**CITY OF NEWPORT BEACH**  
**COMMUNITY DEVELOPMENT DEPARTMENT**  
**BUILDING DIVISION**

Agenda Item No. 2  
November 17, 2020

**SUBJECT:** **7210 W. Ocean Front - Appeal of the Building Official's Determination to Require Drainage and Remove Sliding Glass Door Track from an Unenclosed Loggia on the Third Level**

### THIRD FLOOR PLAN

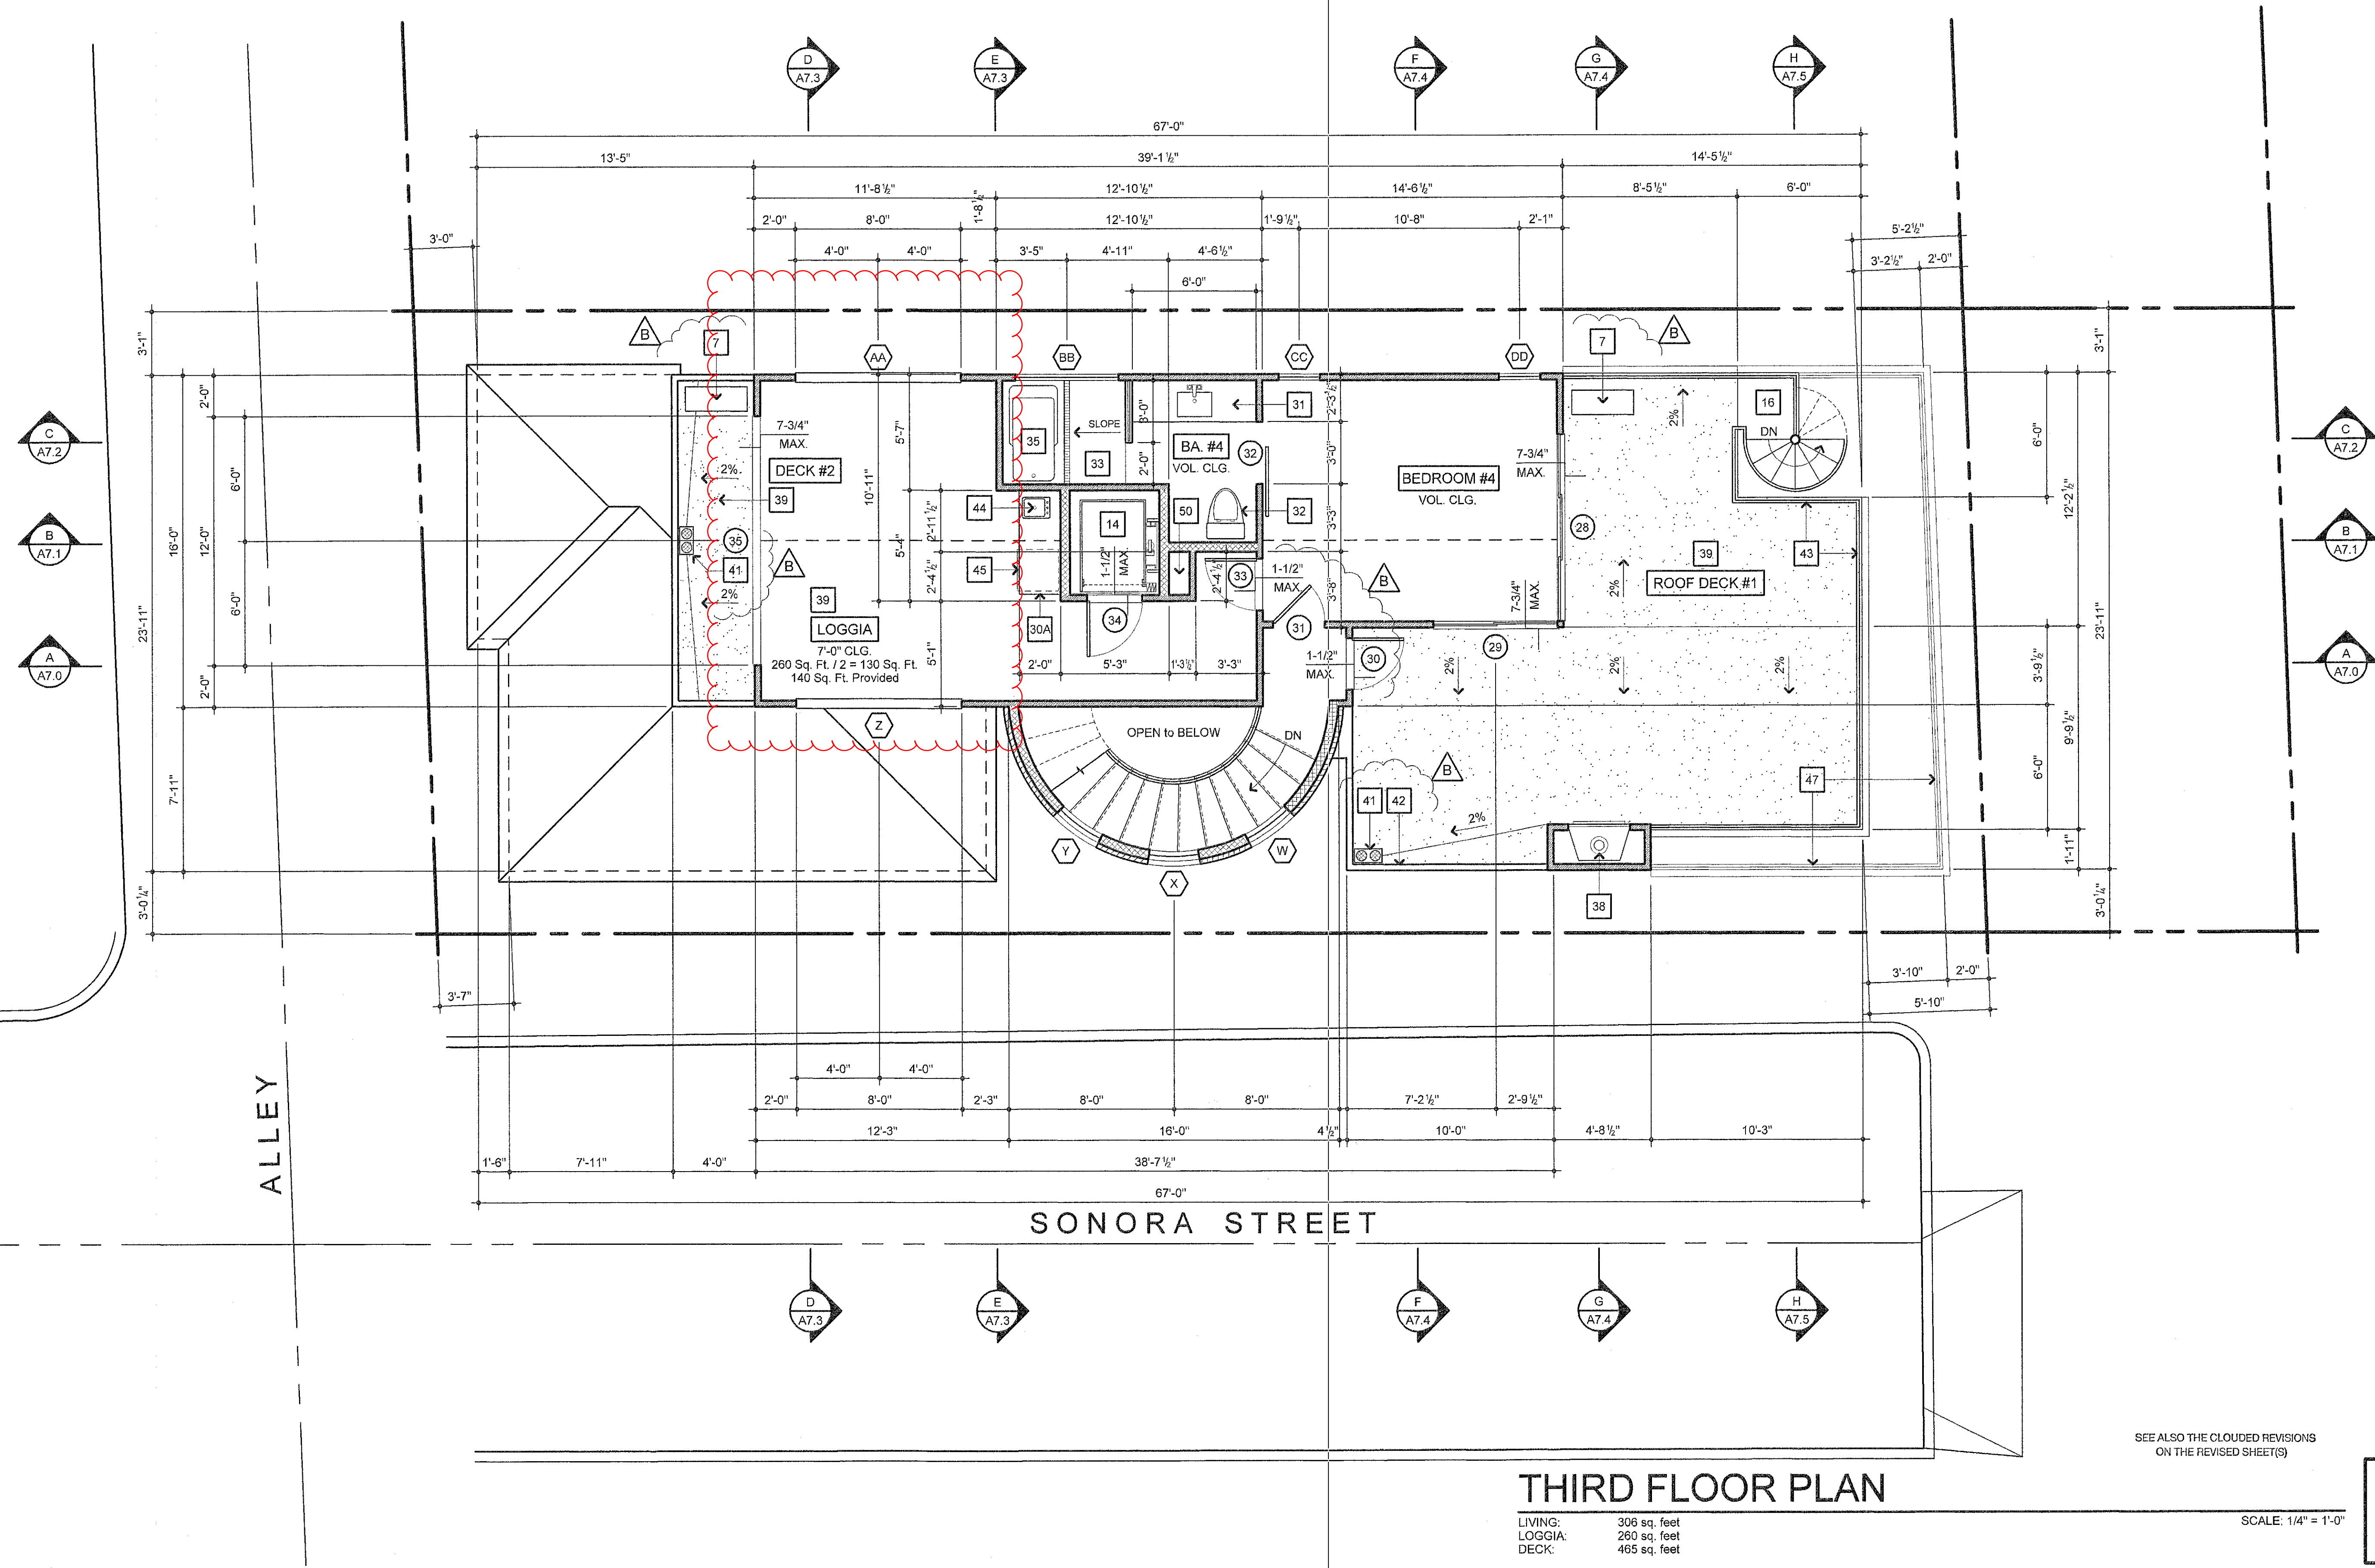
In May of 2020, Mr. Kyle Reeves completed construction of a three-story home including a rooftop loggia ("Loggia") at the property located at 7210 W. Ocean Front. The approved plans specifically show that the opening serving the Loggia to remain open as noted in the attached Exhibit A. In the window schedule for openings, the plans clearly show "cased opening" (Exhibit B). Building Inspector Bill Tuman was in the process of approving final inspections and preparing to issue a Certificate of Occupancy when it was determined that windows and a sliding glass door had been installed to enclose the Loggia as a living space. Enclosing the Loggia conflicts with the approved plans for the project, that clearly and expressly state the Loggia is to remain open. The Loggia must remain open to comply with local Zoning and Building codes.

CRC § R903.4, R903.4.1, R905.9 require a rooftop area exposed to weather to have a drain or slope to divert water from entering the interior of the building. Additionally, Building Inspector Bill Tuman observed that the sliding glass door track compounded the issue by creating a "Dam" by trapping the water within the space without the benefit of drainage device to divert the water to the outside. If water were to creep into the interior of the property it could not only cause water damage, but could also pose a health and safety risk due to the presence of electrical wiring within the first and second floors, and the potential for health hazard like mold growth. Accordingly, Mr. Reeves was advised that the water drainage issue would have to be corrected and the sliding door track must be removed prior to issuance of a Certificate of Occupancy.

Staff recommends that the Board uphold the Chief Building Official's determination requiring the owner to provide adequate drainage method or devices to the unenclosed Loggia area that is exposed to weather as required by the California Residential Building Code ("CRC"), and to remove the sliding door track that was installed contrary to the approved plans.
